Final Drainage Report

Palmer Solar Facility El Paso County, Colorado

AASI-18-006

**MAP NUMBER
 08041C0970 F**

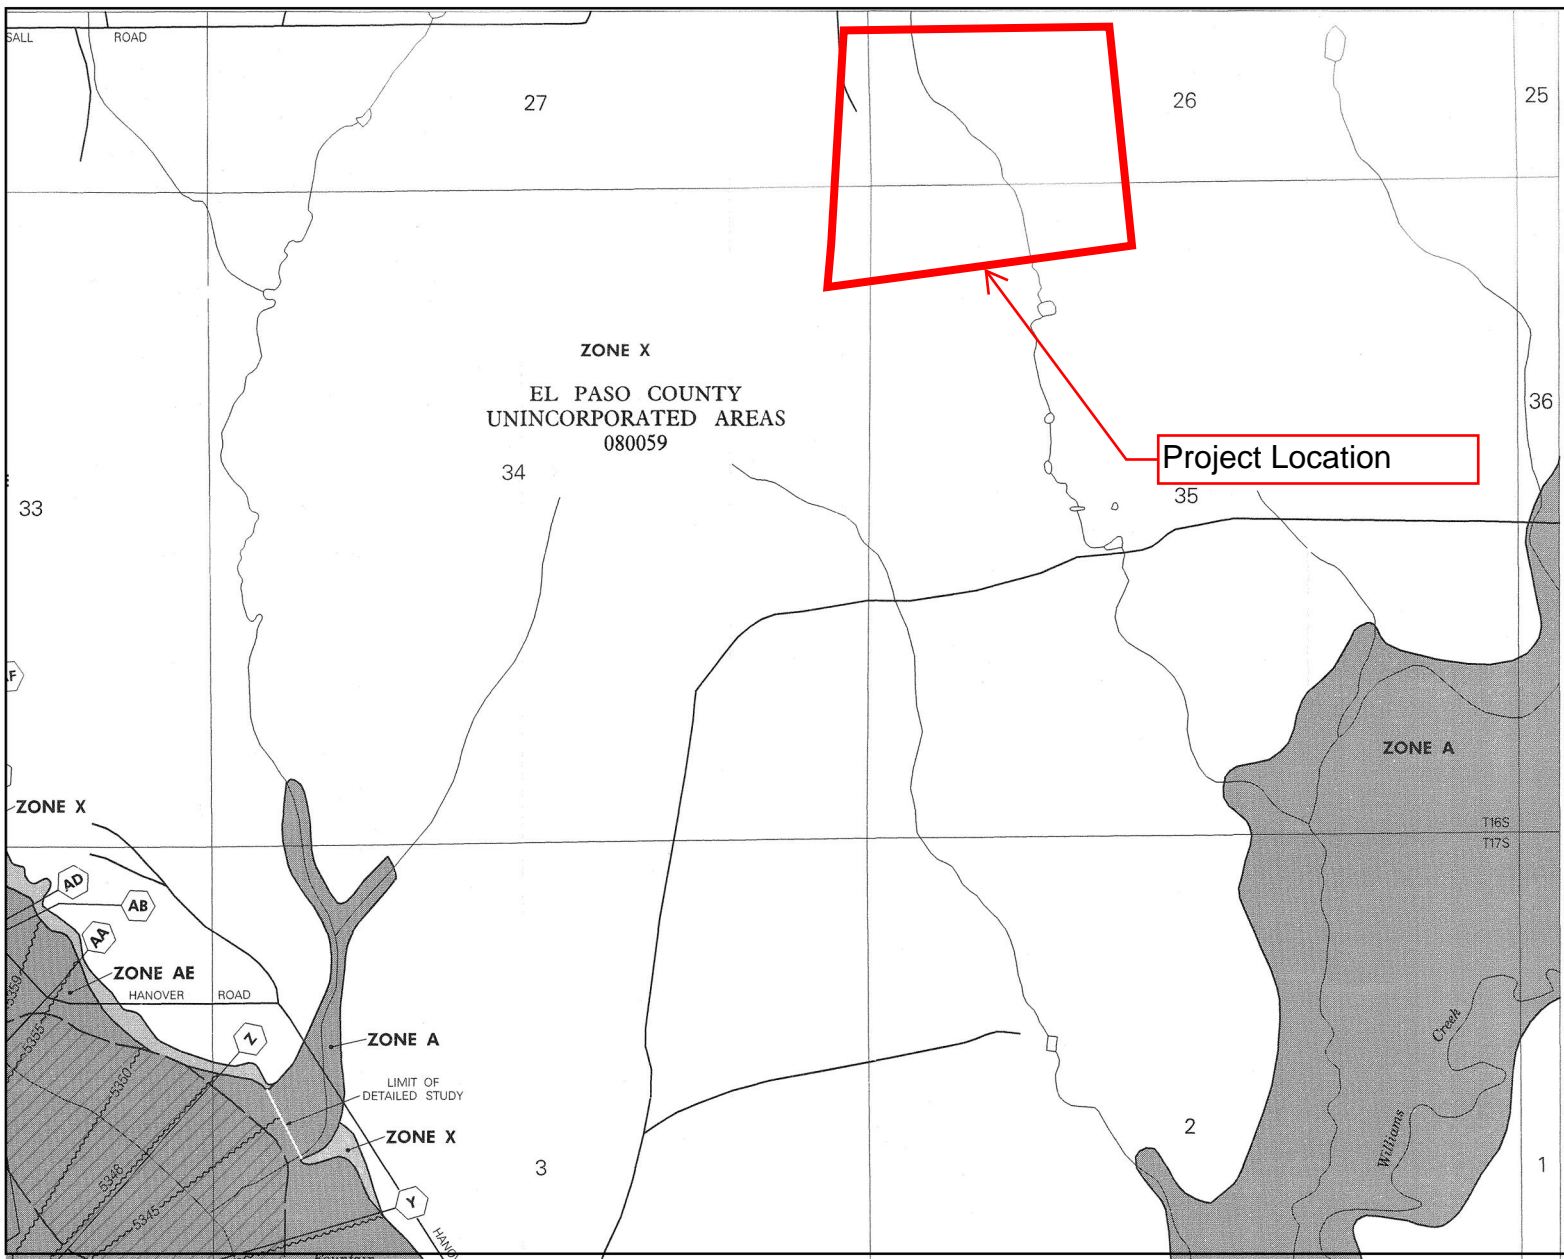
Provide the updated FIRM maps. Effective Date
 December 7, 2018.

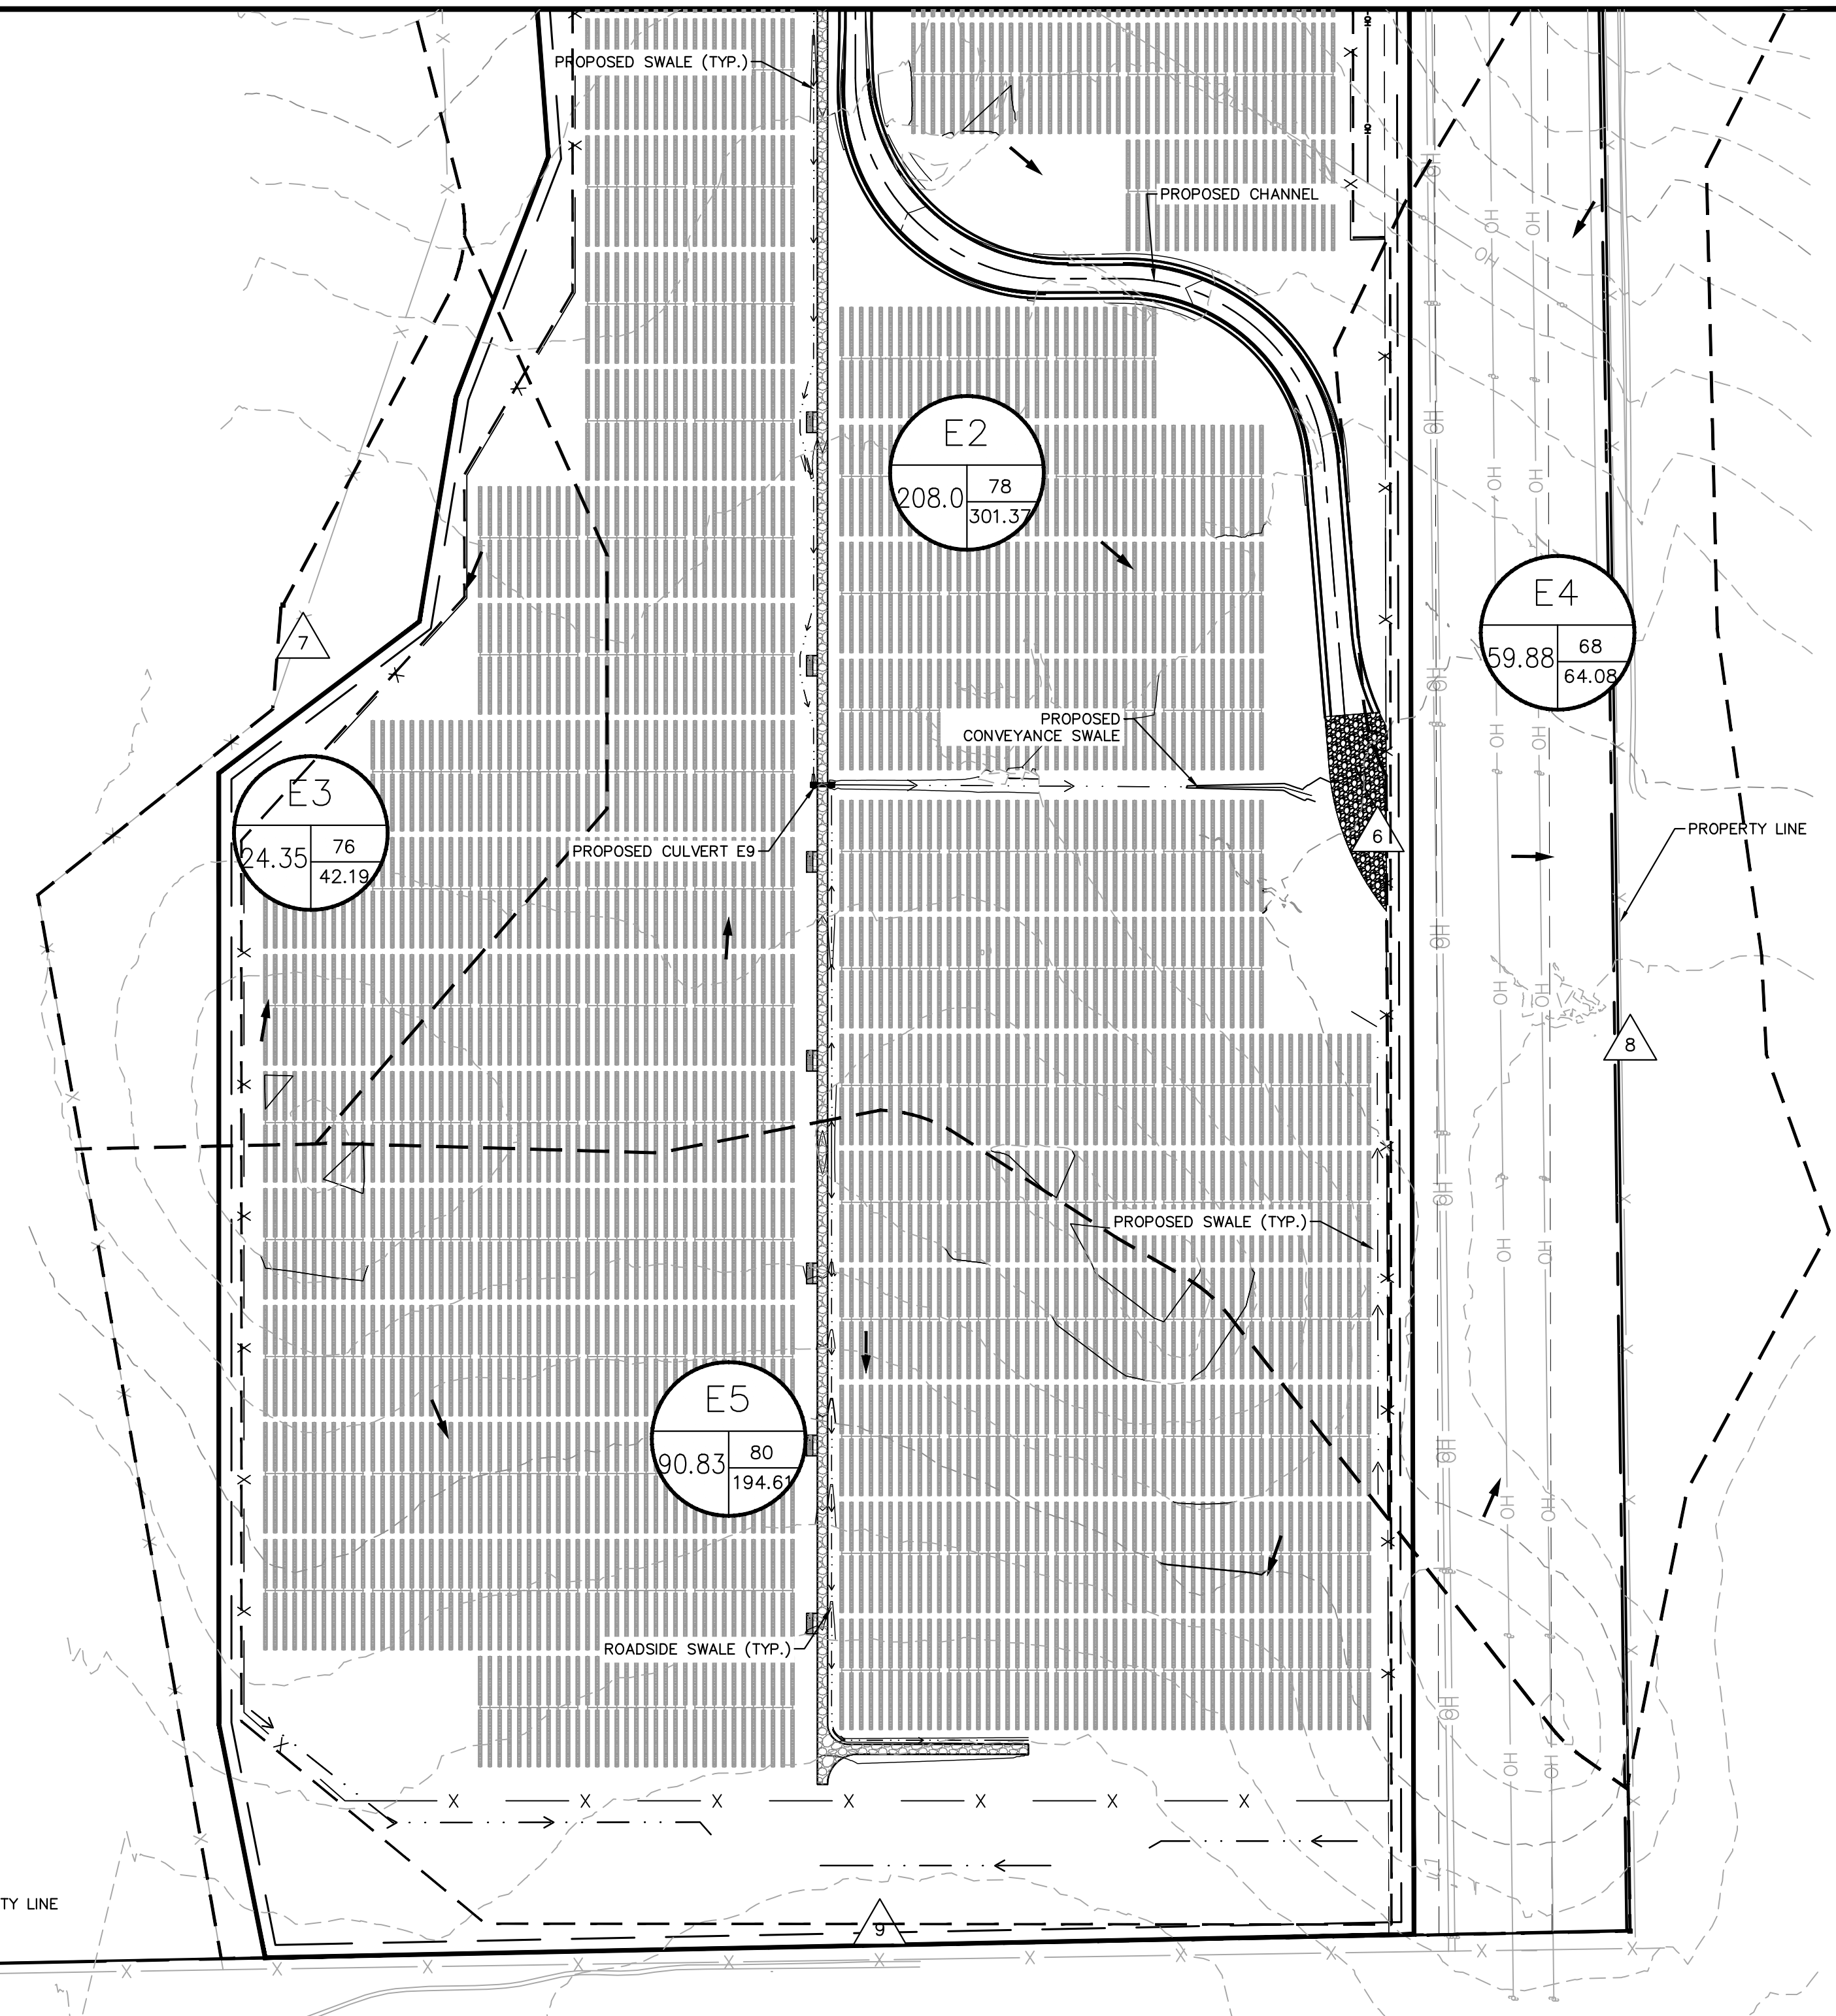
Provide design point summary table.
